KING'S HEAD
Tenant Fit Up

Merrill's Wharf
Portland, Maine

PERMIT DOCUMENTS
JUNE 8 2013
Layout Plan
Scale: As Noted

A 101

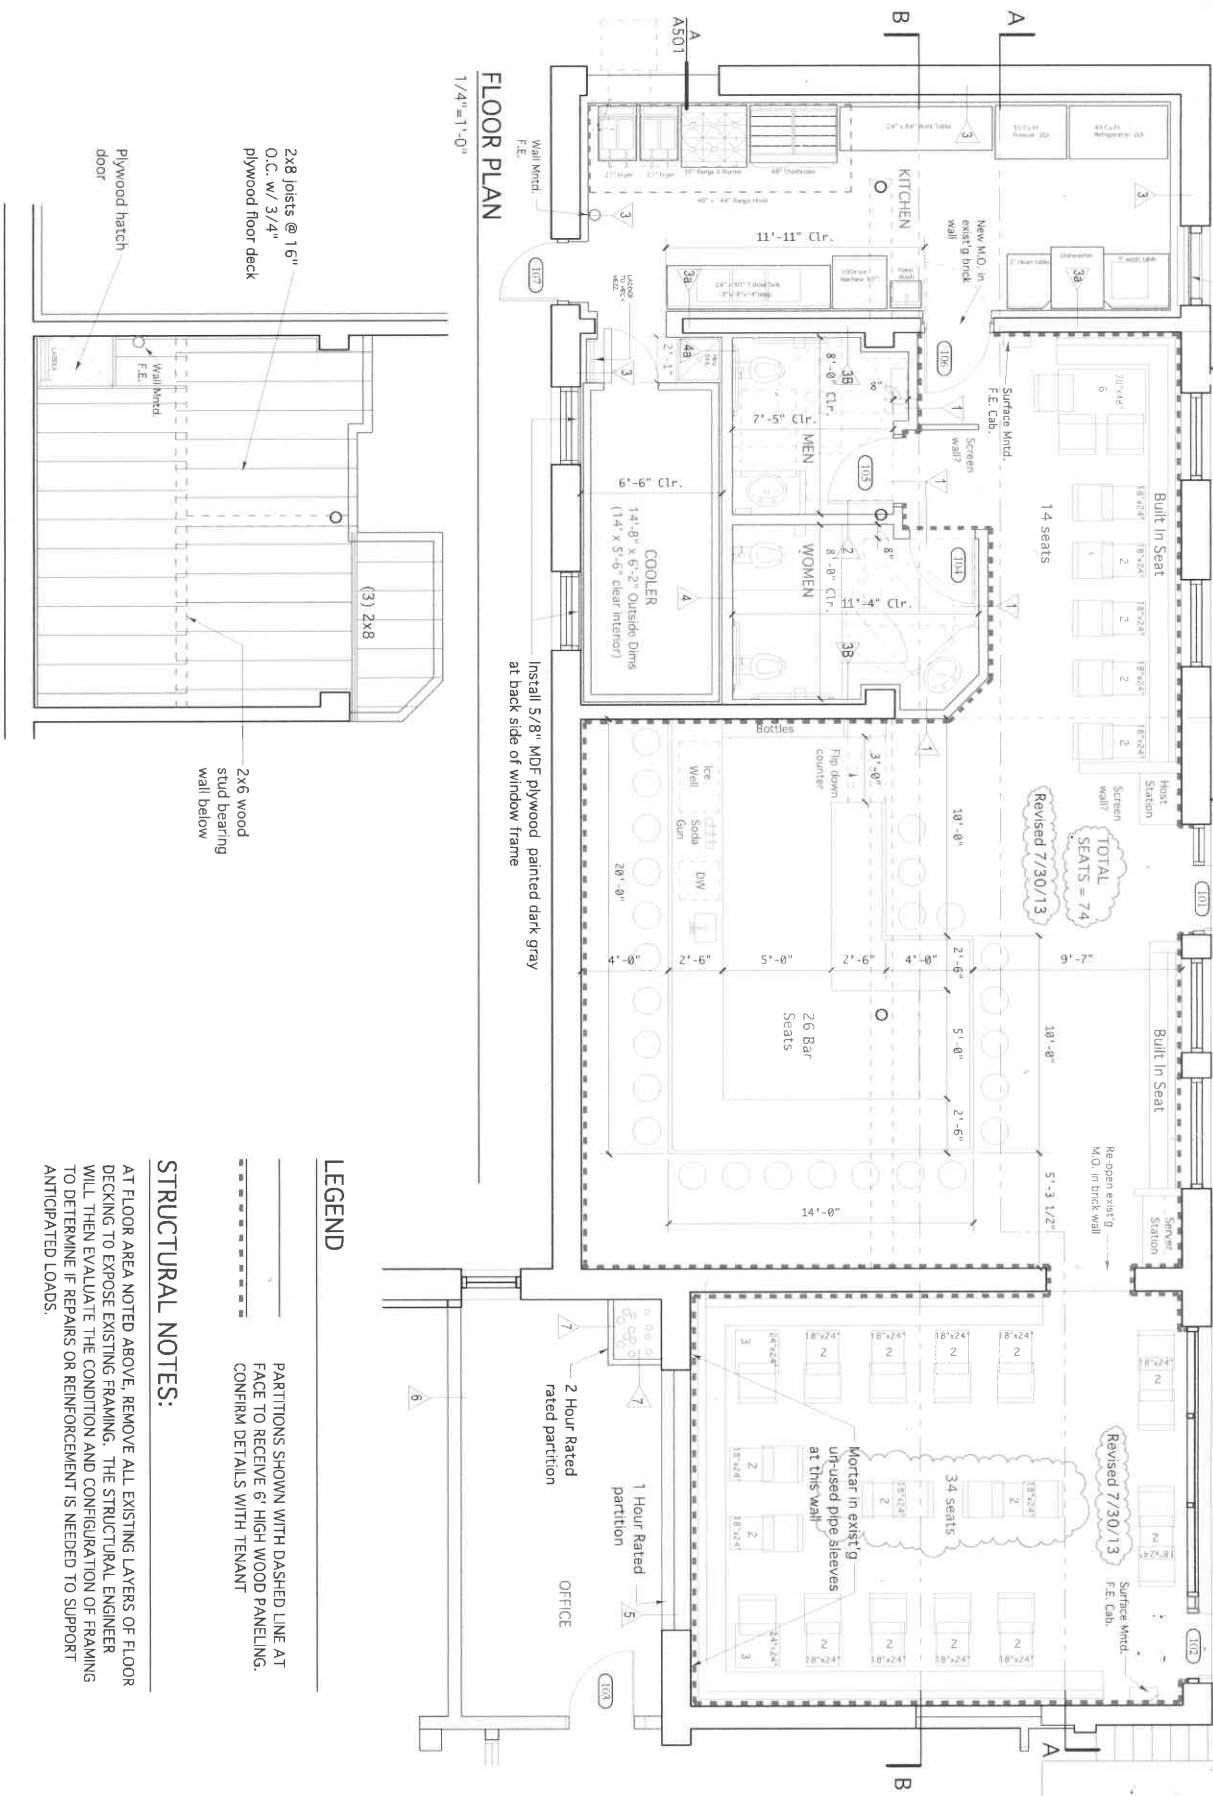
Handwritten: SIGN BOARD

Handwritten: STALLS W/ BAR
